TRANS/WP.29/GRSG/2002/12
7 August 2002

World Forum for Harmonization of Vehicle Regulations (WP.29)

PROPOSAL FOR DRAFT 01 SERIES OF AMENDMENTS TO REGULATION No. 107
(M2 and M3 vehicles)

Transmitted by the expert from the International Organization of
Motor Vehicles Manufacturer (OICA)

Figure 1

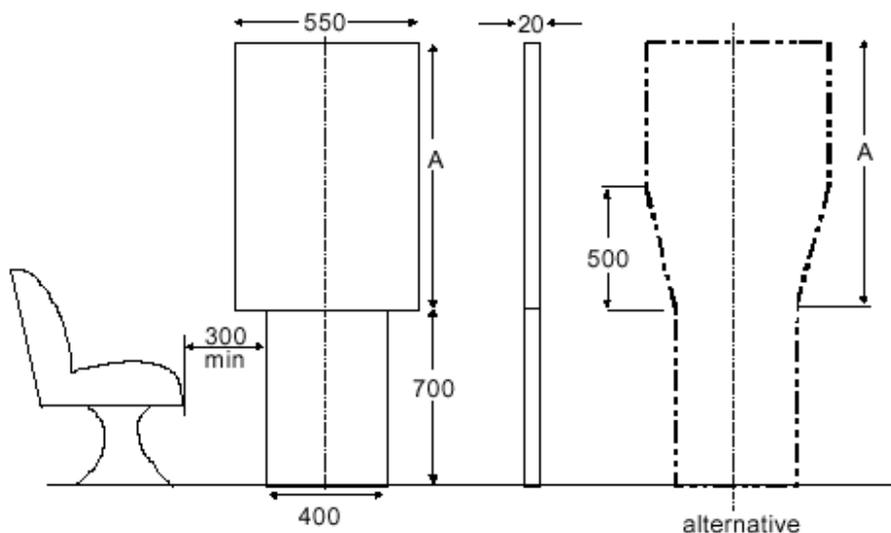
As shown above but with chamfer as Regulation No. 52 and units in cm (shown in mm)

Figure 2

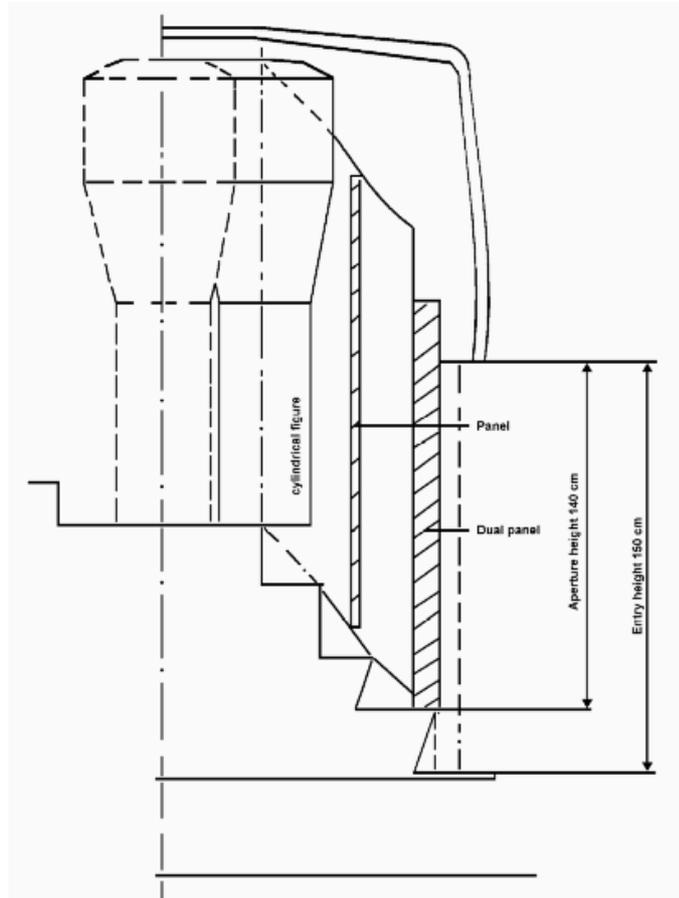
Note: Diagram should be clarified to identify the panels concerned by reference to their respective paragraphs/figures.

Figure 4

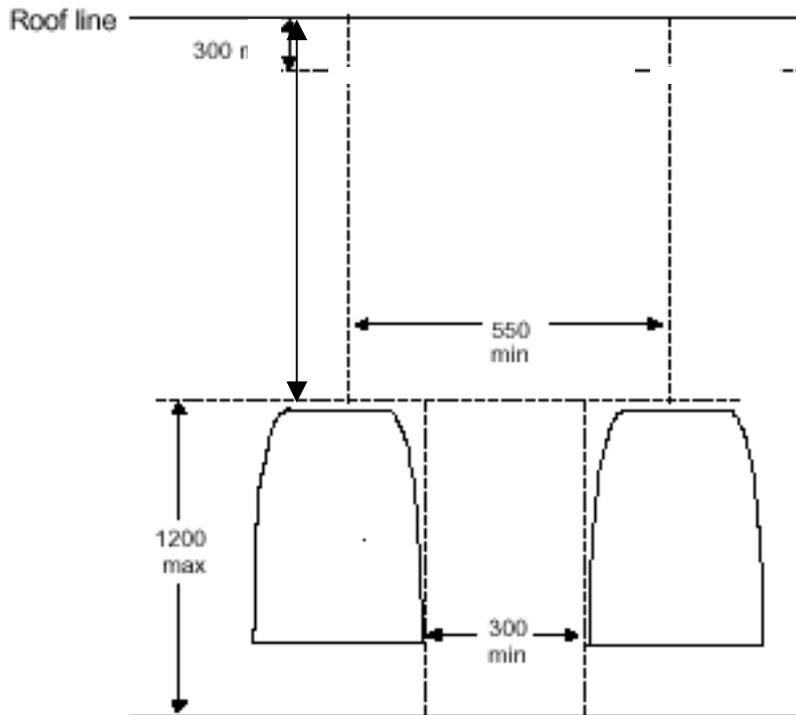
As shown above but with units in cm (shown in mm)

Figure 5

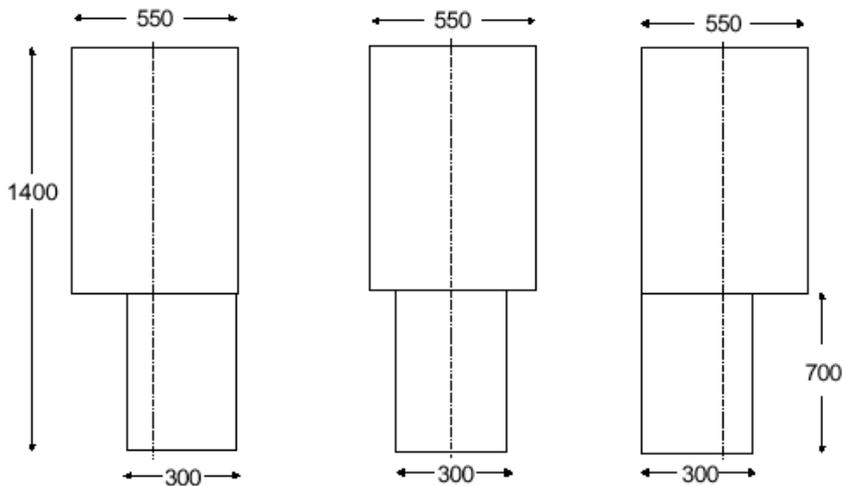
Diagrams should be redrawn to include chamfer at top, as provided for in paragraph 5.7.2.1. (see Regulation No. 52), and with units in cm (shown in mm)

Figure 6

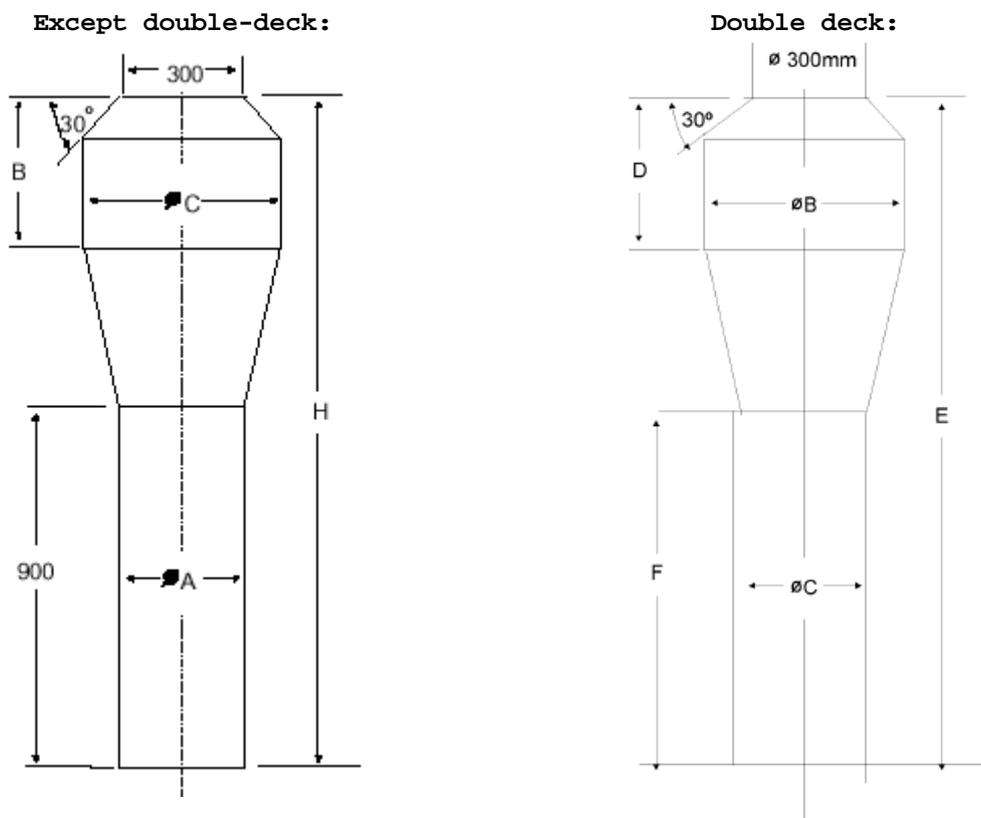
As shown above but with units in cm (shown in mm)

Figure 10

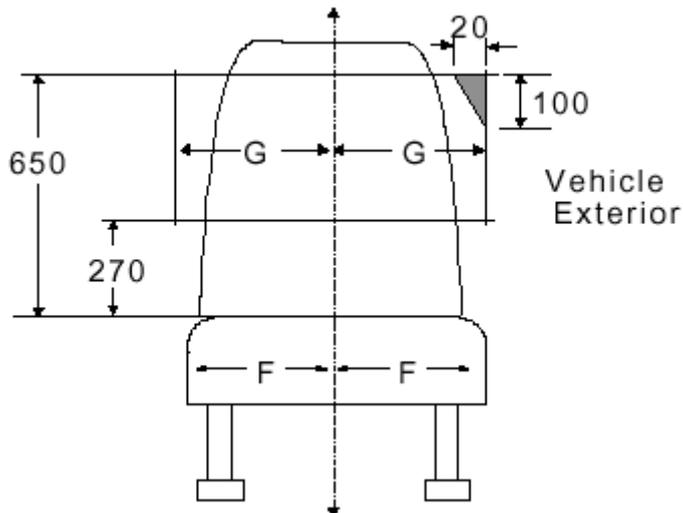
As shown above but with units in cm (shown in mm)

Figure 14

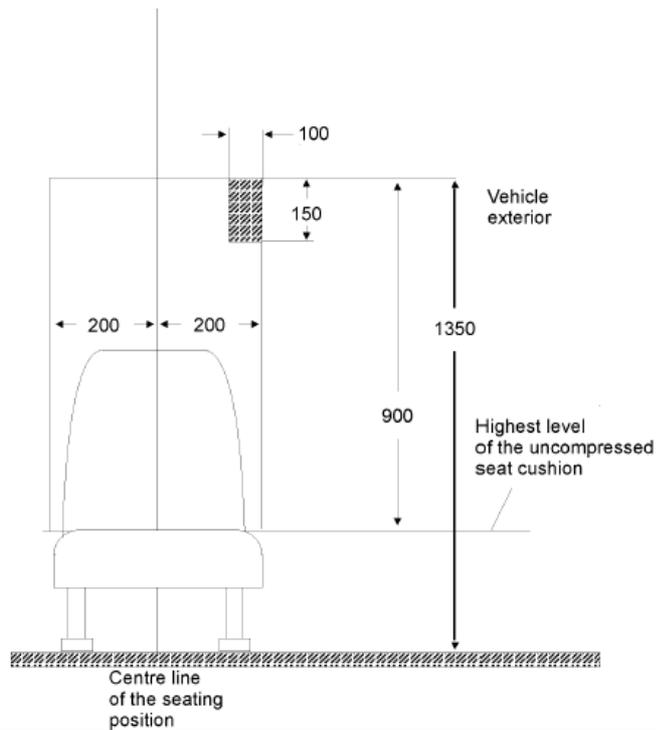
As shown above but with units in cm (shown in mm)

Figure 15

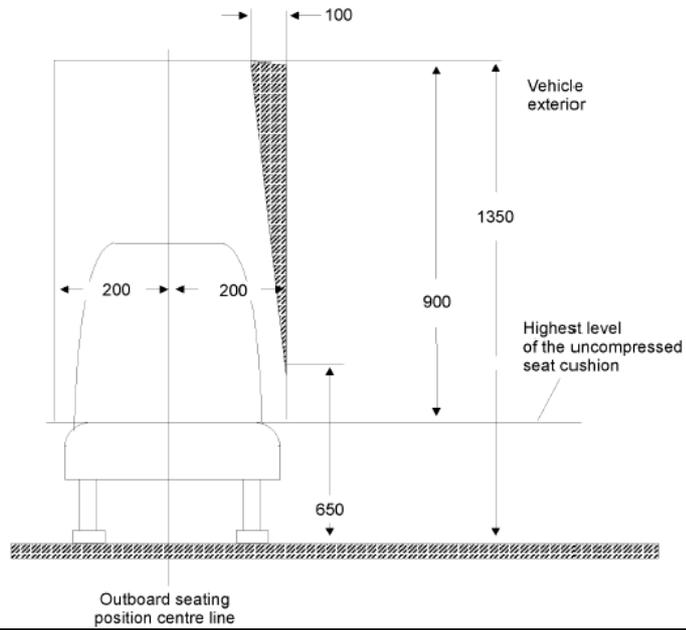
As shown above but with units in cm (shown in mm)

Figure 16

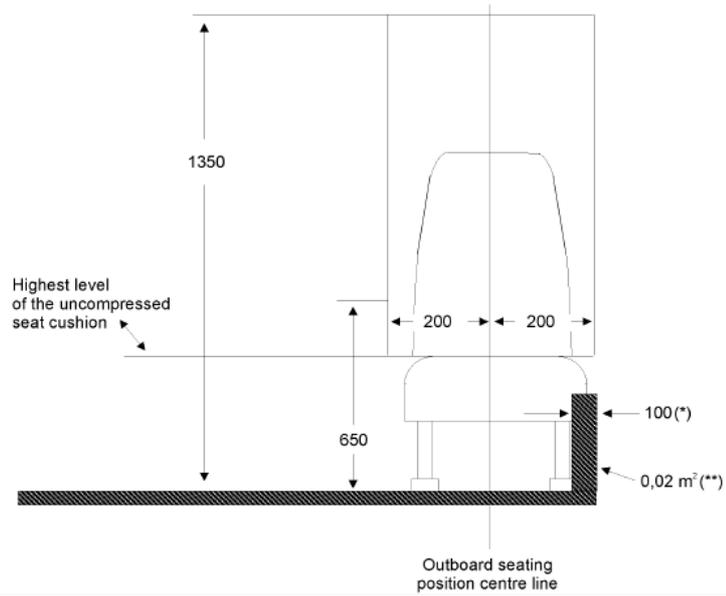
As shown above but with units in cm (shown in mm)

Figure 19

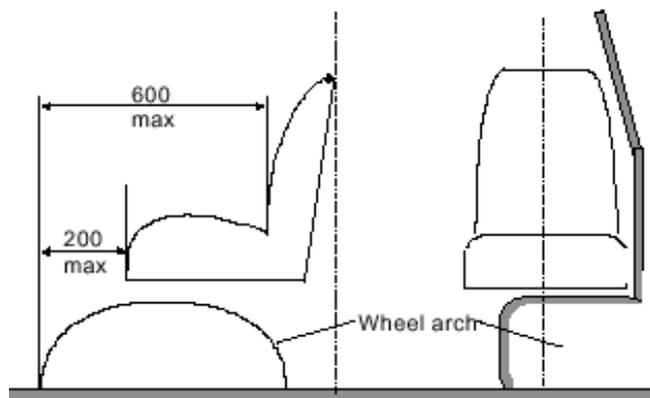
As shown above but with units in cm (shown in mm)

Figure 23

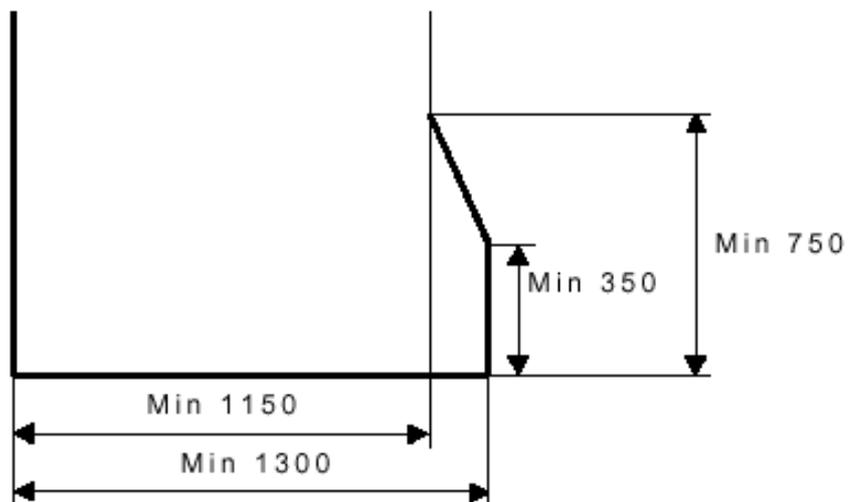
As shown above but with units in cm (shown in mm)
